## Ground Water Consultants, LLC

September 20, 2022

Re: Review of Aquifer Hydrogeological Report prepared for UW Brazos Valley Farm LLC  
Regarding Well Permit Applications for Barton, Goodland and Harlan Farms in  
Robertson County, Texas

**Figure 3 - Wells and Buffers**

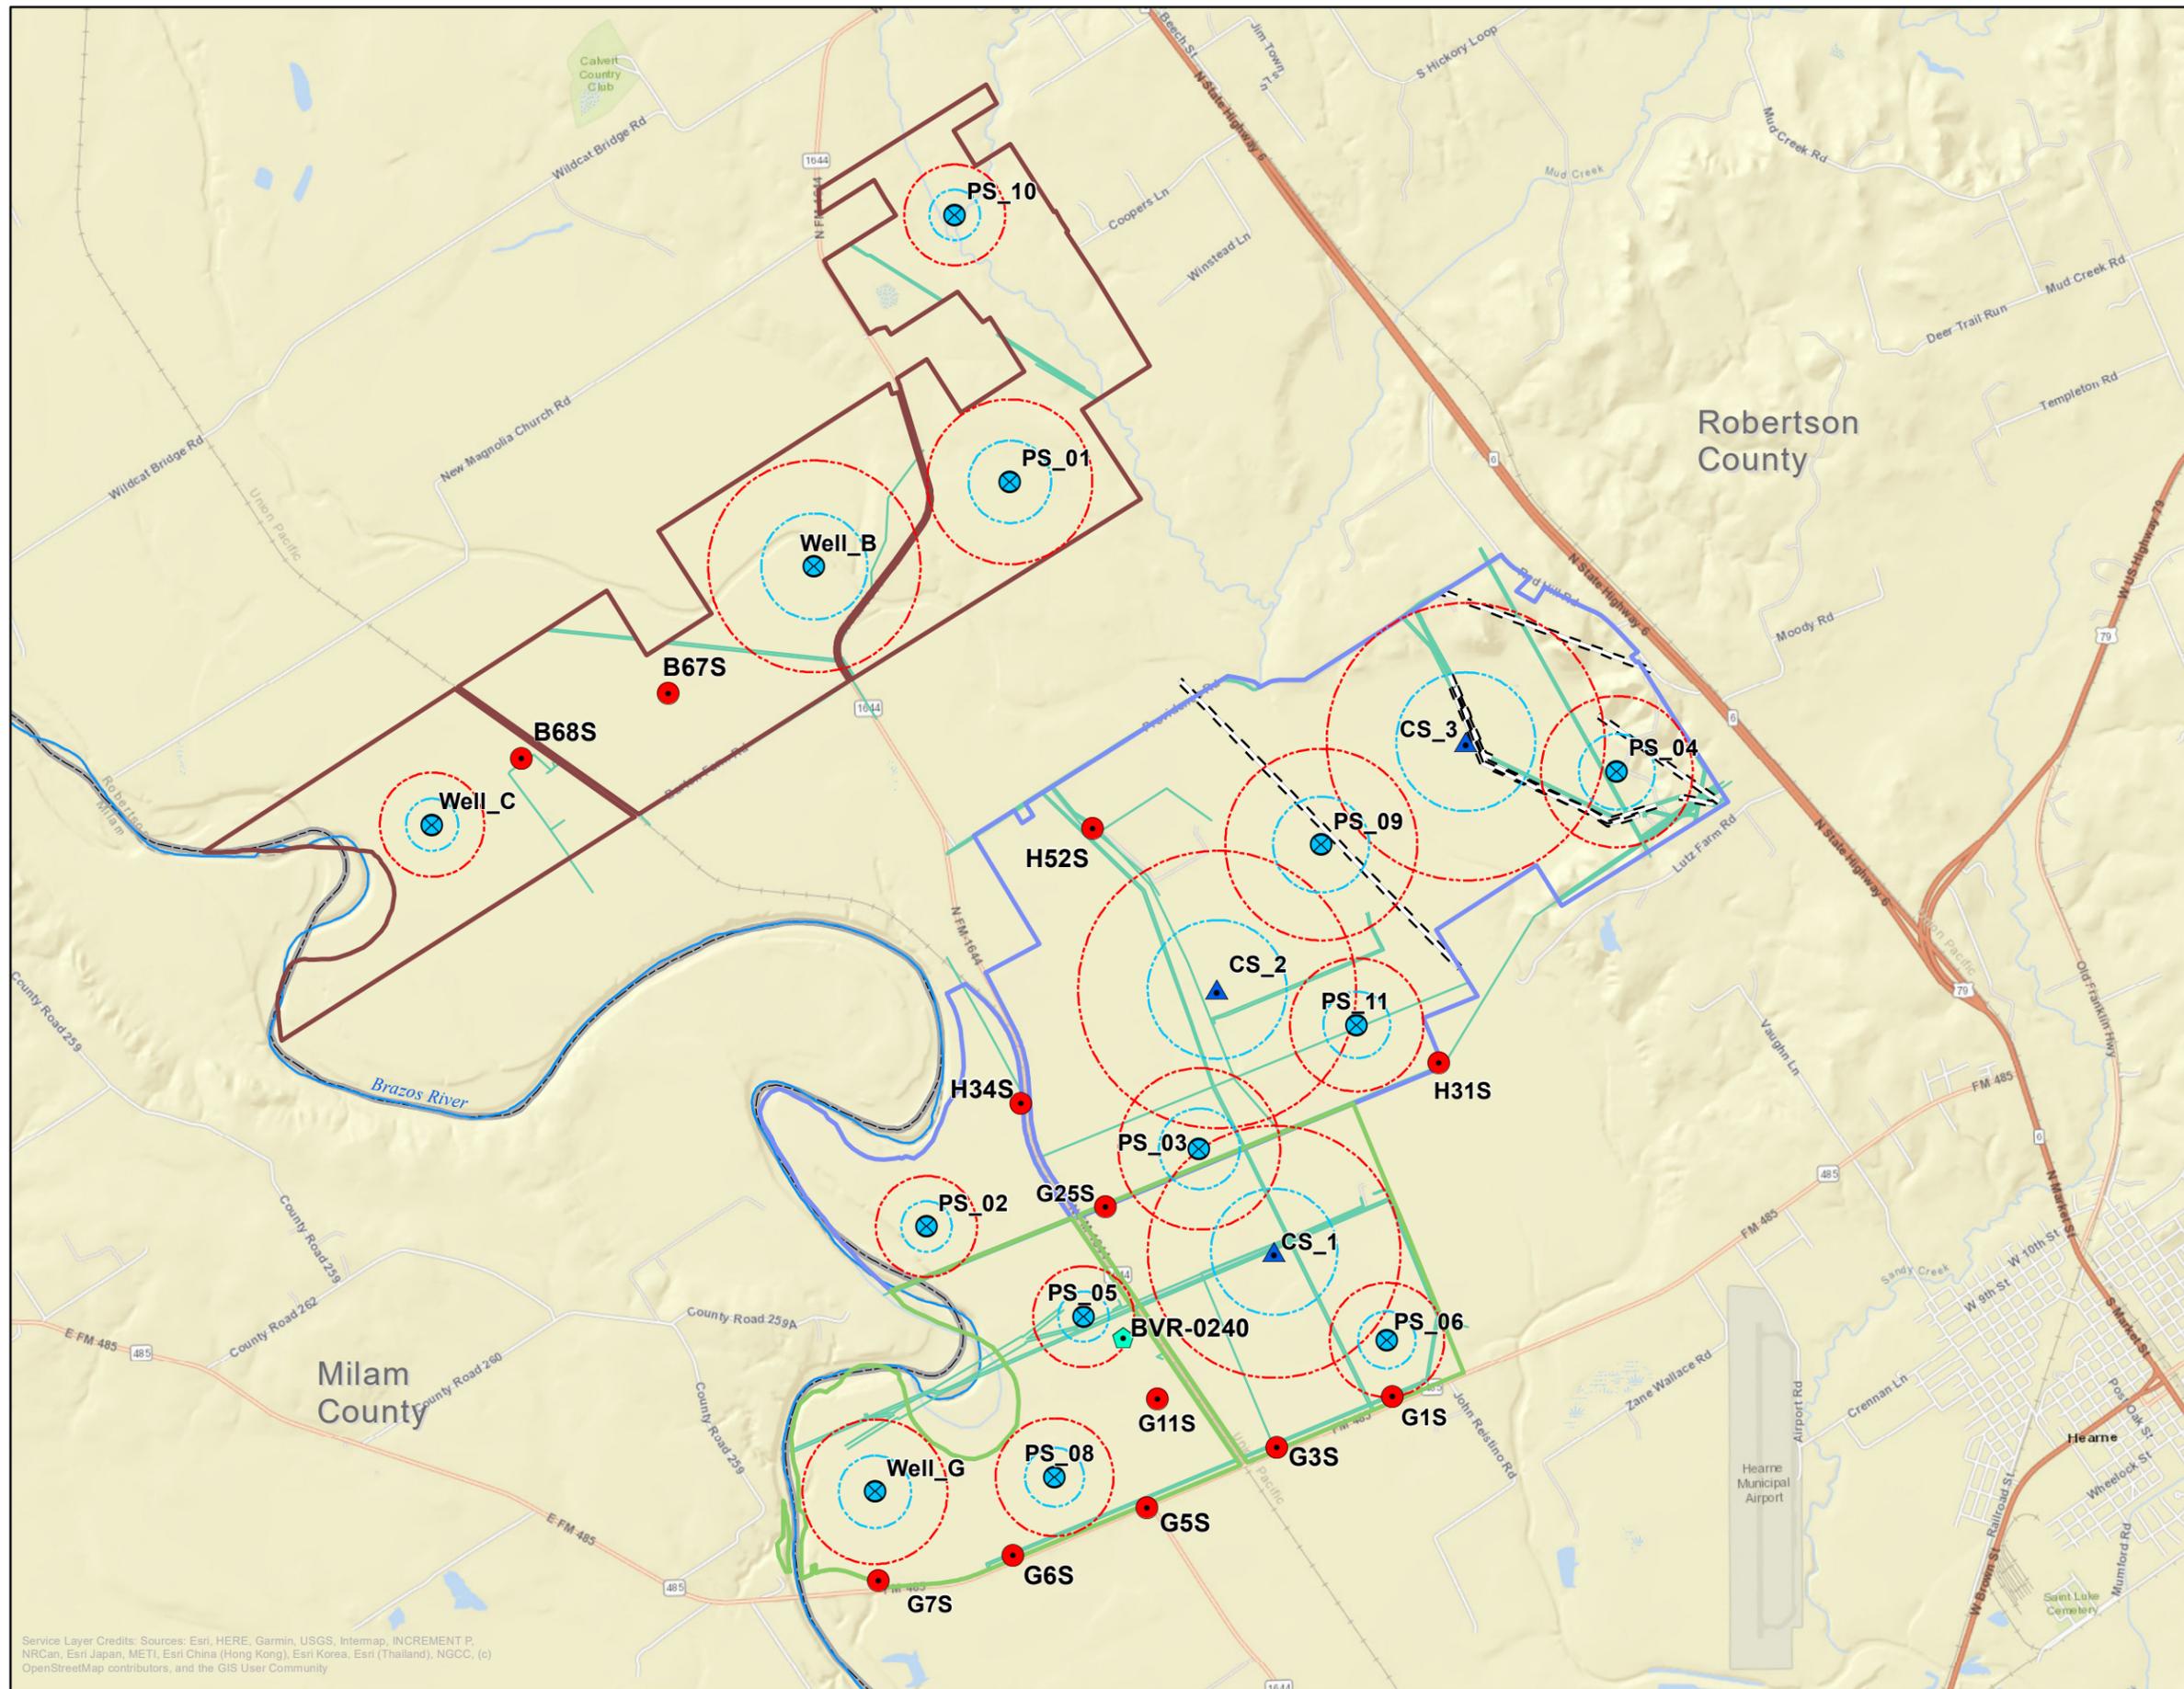
The permit application for the thirteen wells is for an overall withdrawal amount of 34,516 ac-ft/yr that is planned to be added to the existing permits for three wells with a total withdrawal of 15,483 ac-ft/yr. The combination of the 34,516 and 15,483 ac-ft/yr will bring the total permit amount of the sixteen wells to 49,999 ac-ft/yr. The proposed maximum pumping rates of the wells range from 1,500 to 3,300 gpm. The proposed locations for the wells with circles around them are shown on the attached figure, which was provided as part of the hydrogeological report.

**Figure 7 - Wells within 1 Mile**

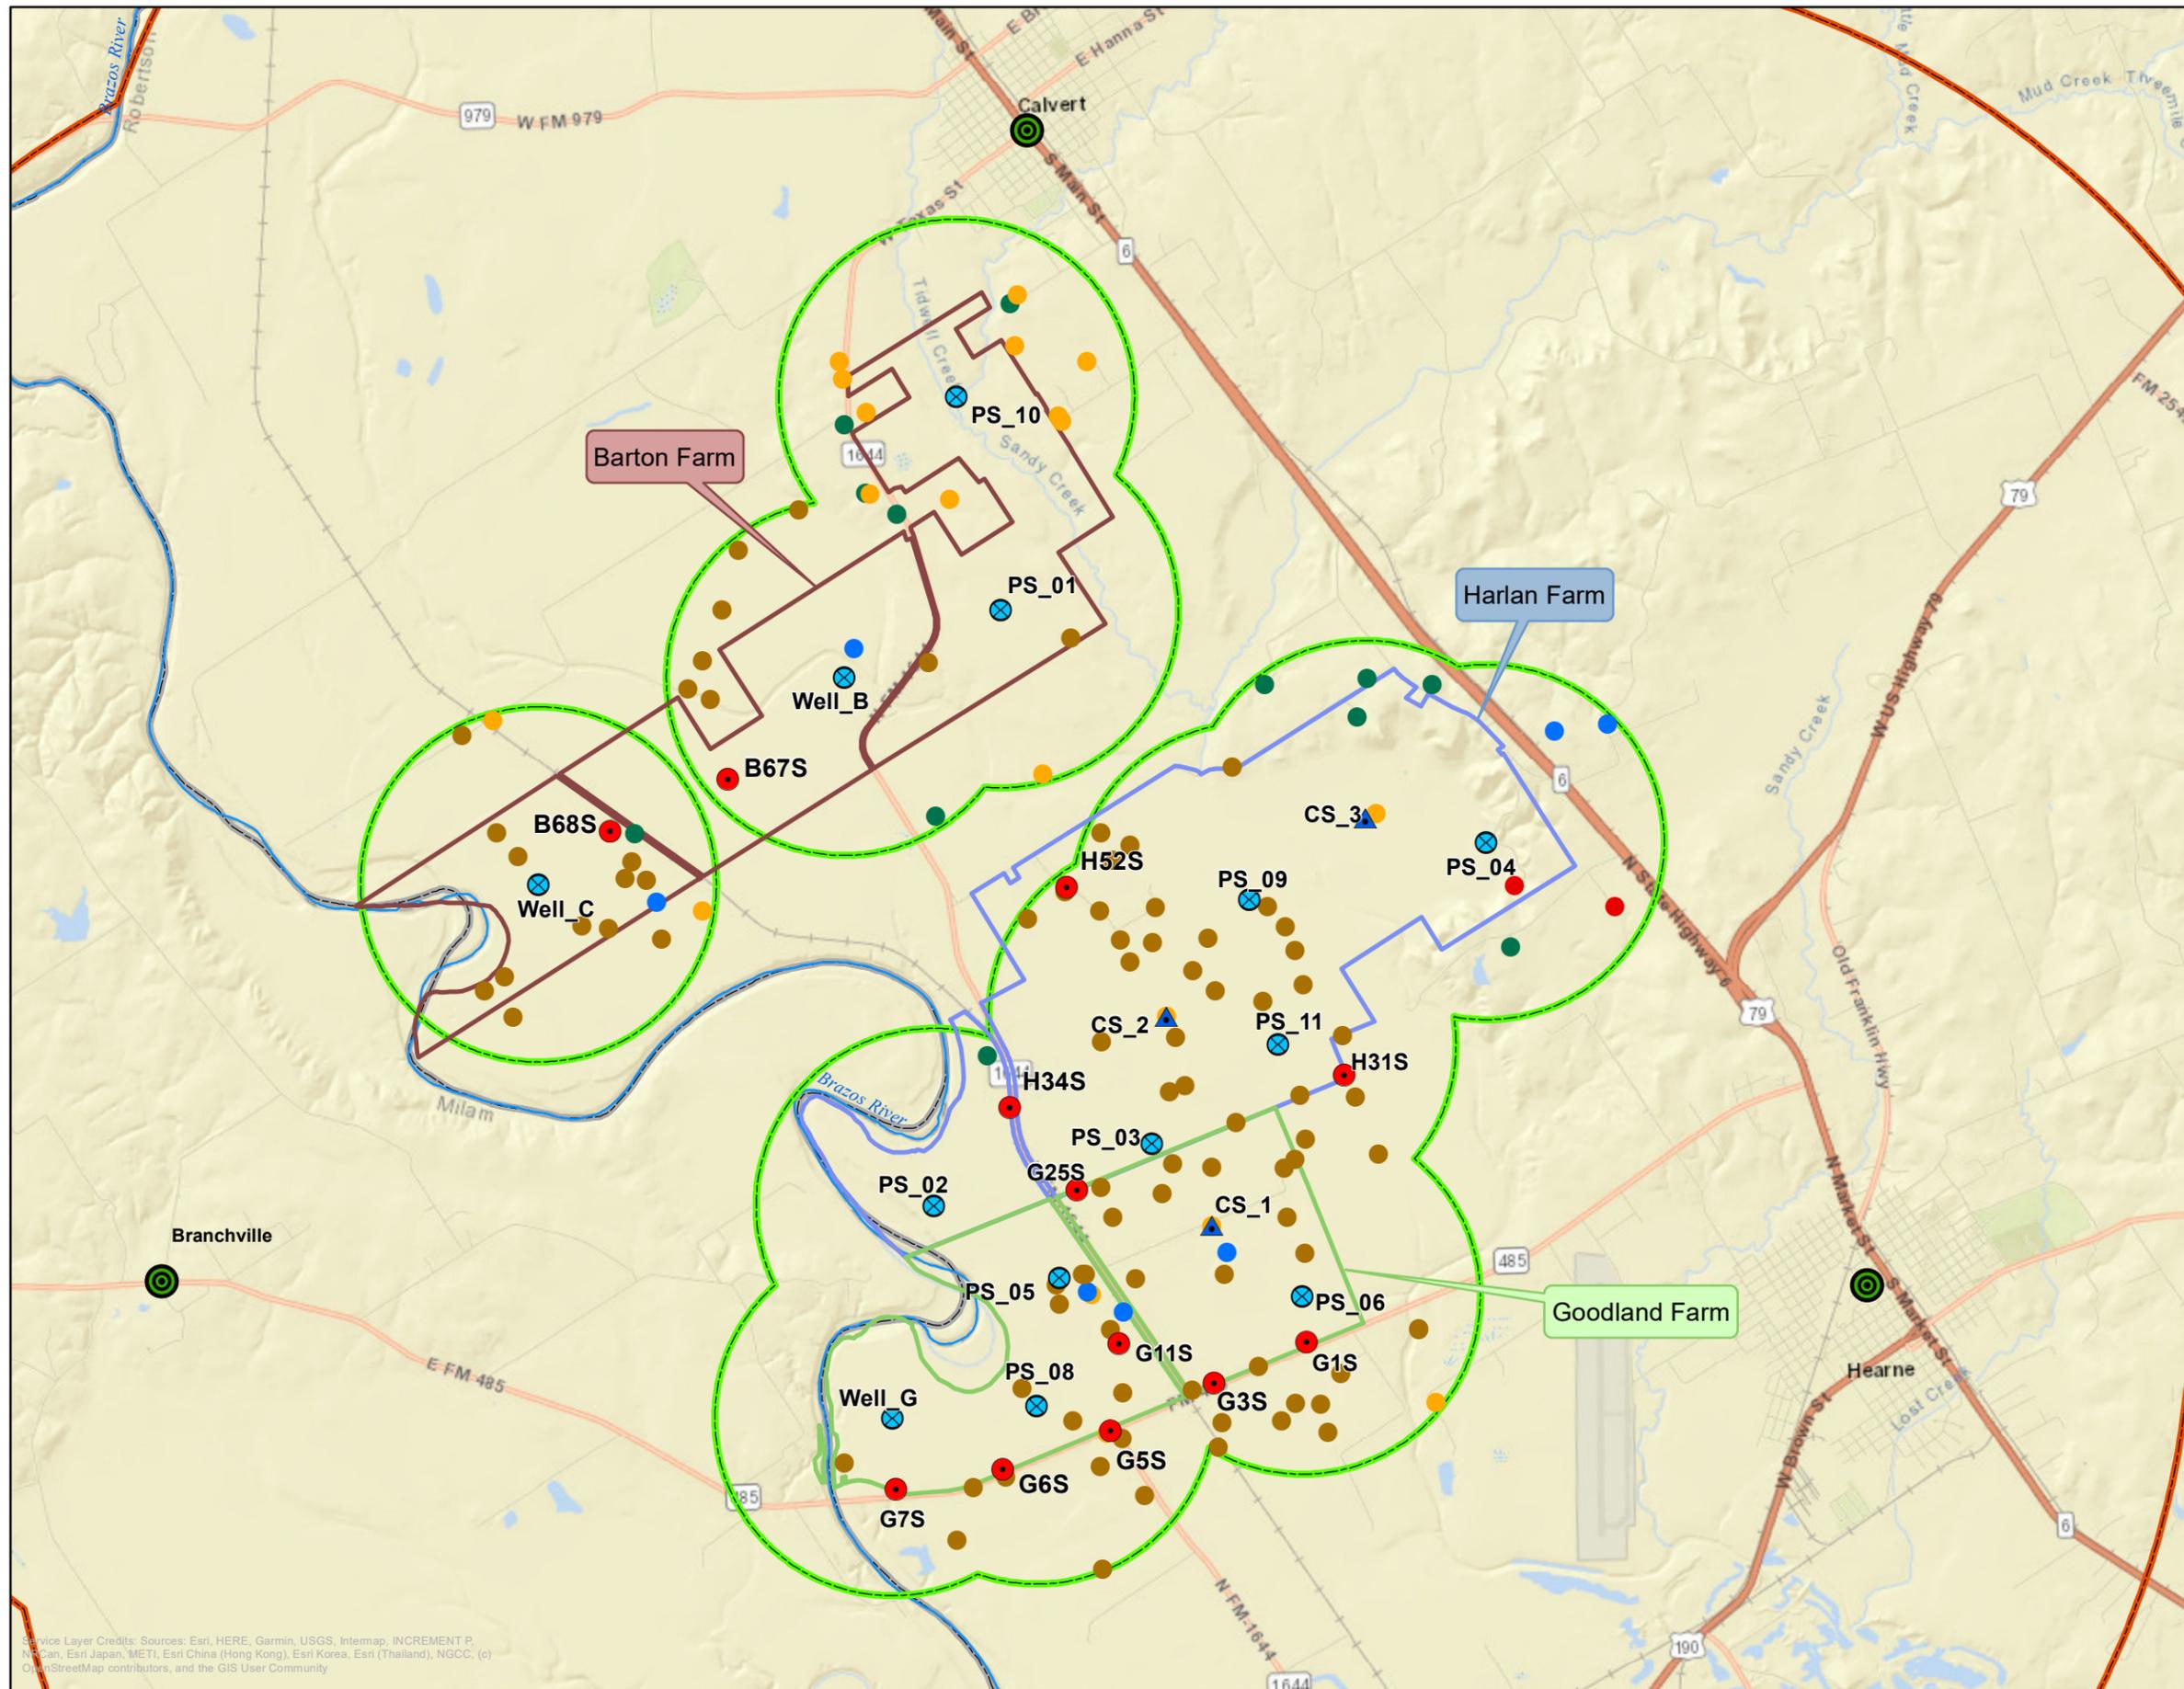
2. As required by the Rule 8.4(b)(7)(B)(2), Table 2 in the first report provides data regarding the 15 water wells that are located within one mile of the proposed well locations and screen the same Simsboro Aquifer as the proposed wells. A copy of Figure 7 from the first report is attached showing the locations of the 15 wells as small solid yellow circles.
